**SAVAGE SUBDIVISION – PRELIMINARY PLAT**

**CITY COUNCIL MEETING**

**JULY 21, 2022**

**PRELIMINARY CIVIL PLAN**

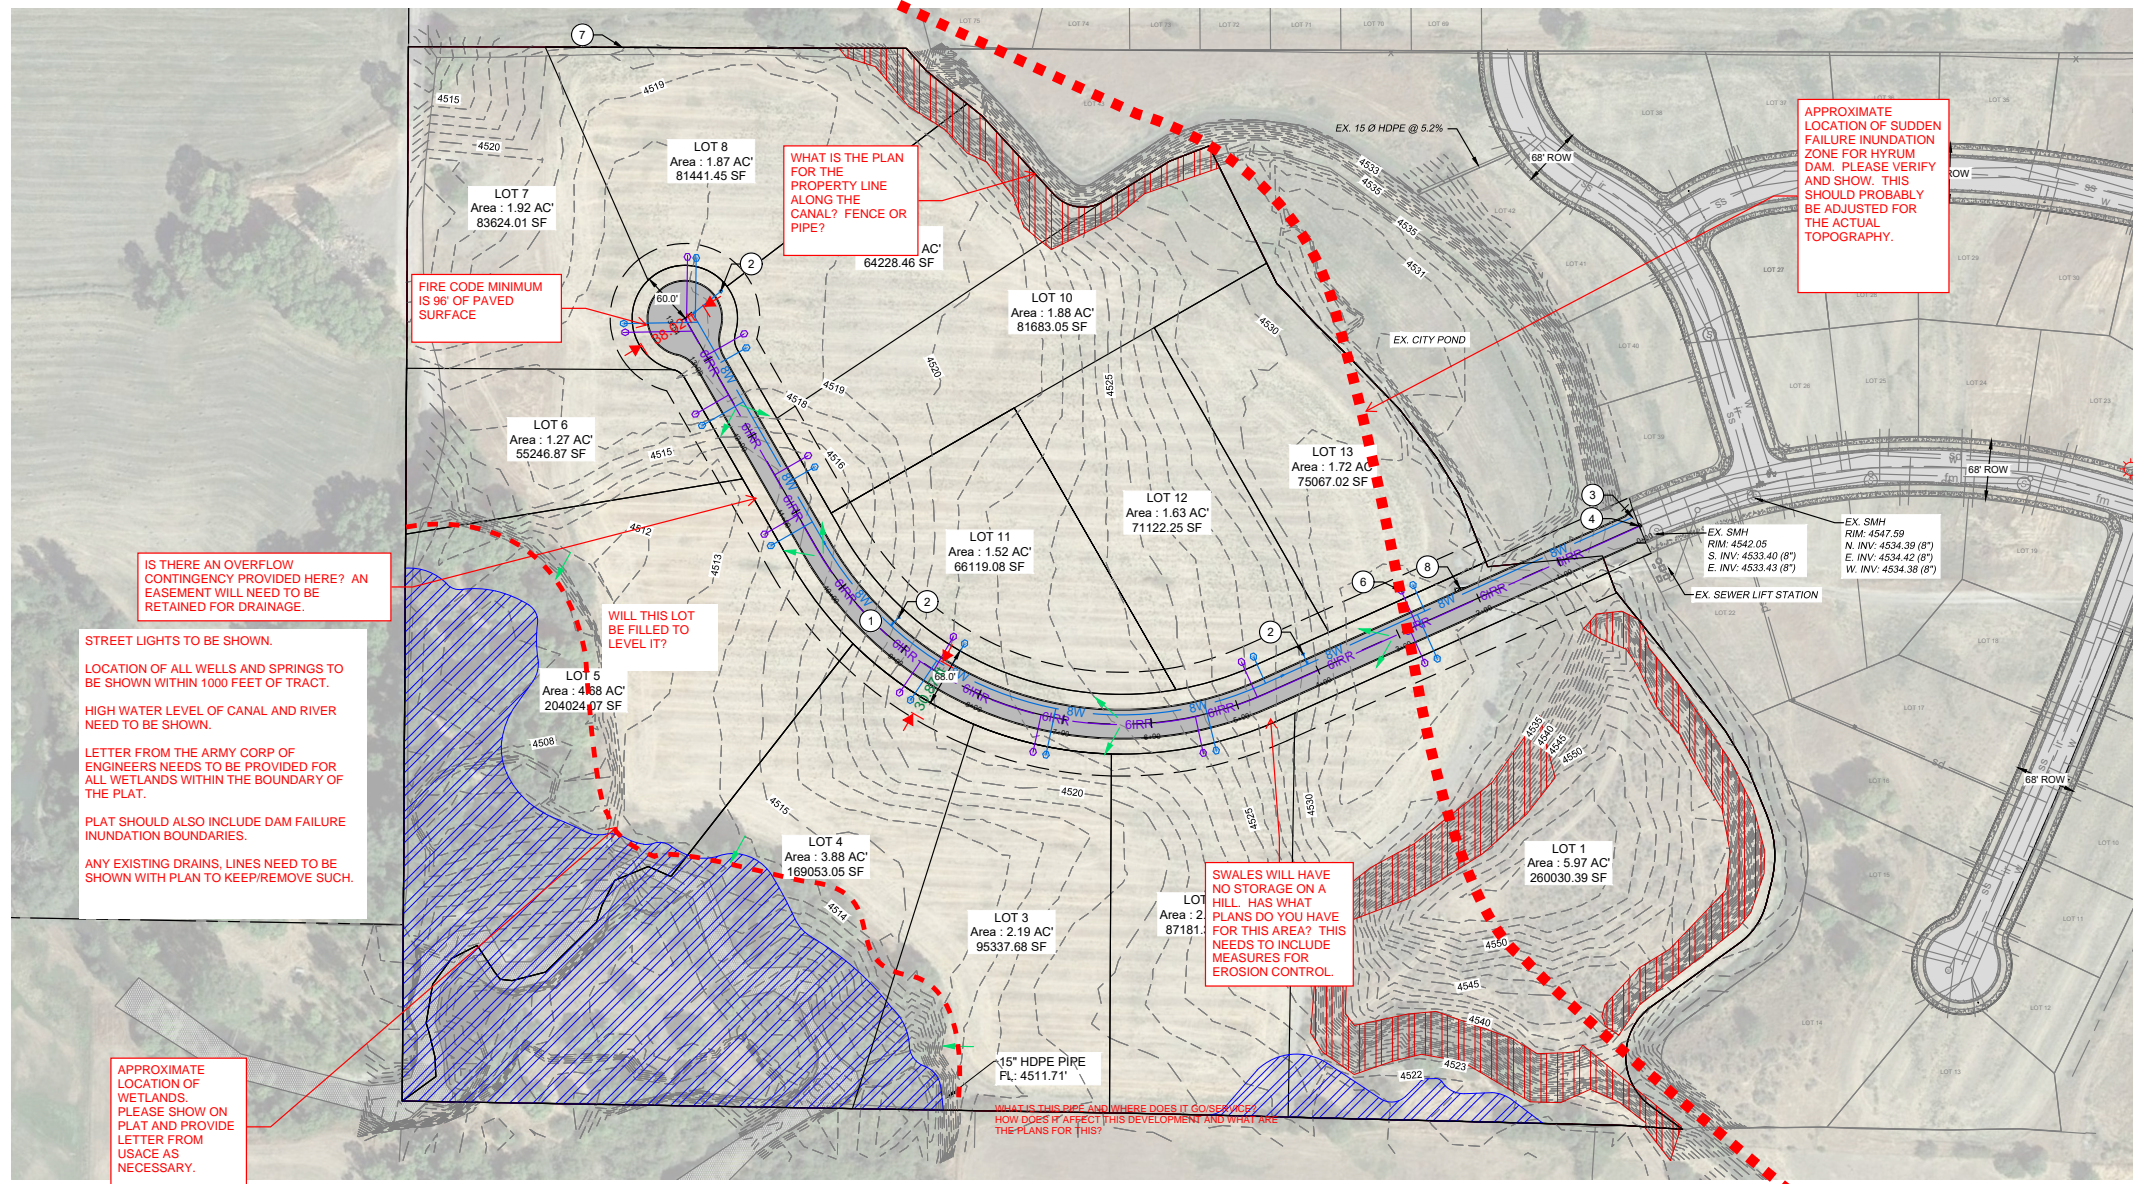
IS THERE AN OVERFLOW CONTINGENCY PROVIDED HERE? AN EASEMENT WILL NEED TO BE RETAINED FOR DRAINAGE.

STREET LIGHTS TO BE SHOWN. LOCATION OF ALL WELLS AND SPRINGS TO BE SHOWN WITHIN 1000 FEET OF TRACT.

HIGH WATER LEVEL OF CANAL AND RIVER NEED TO BE SHOWN.

LETTER FROM THE ARMY CORP OF ENGINEERS NEEDS TO BE PROVIDED FOR ALL WETLANDS WITHIN THE BOUNDARY OF THE PLAT.

PLAT SHOULD ALSO INCLUDE DAM FAILURE INUNDATION BOUNDARIES.

ANY EXISTING DRAINAGE LINES NEED TO BE SHOWN WITH PLAN TO KEEP/REMOVE SUCH.

APPROXIMATE LOCATION OF WETLANDS. PLEASE SHOW ON PLAT AND PROVIDE LETTER FROM USACE AS NECESSARY.

WHAT IS THE PLAN FOR THE PROPERTY LINE ALONG THE CANAL? FENCE OR PIPE?

APPROXIMATE LOCATION OF SUDDEN FAILURE INUNDATION ZONE FOR HYRUM DAM. PLEASE VERIFY AND SHOW. THIS SHOULD PROBABLY BE ADJUSTED FOR THE ACTUAL TOPOGRAPHY.

SWALES WILL HAVE NO STORAGE ON A HILL. HAS WHAT PLANS DO YOU HAVE FOR THIS AREA? THIS NEEDS TO INCLUDE MEASURES FOR EROSION CONTROL.

WHAT IS THIS PIPE AND WHERE DOES IT GO/SERVE? HOW DOES IT AFFECT THIS DEVELOPMENT AND WHAT ARE THE PLANS FOR THIS?
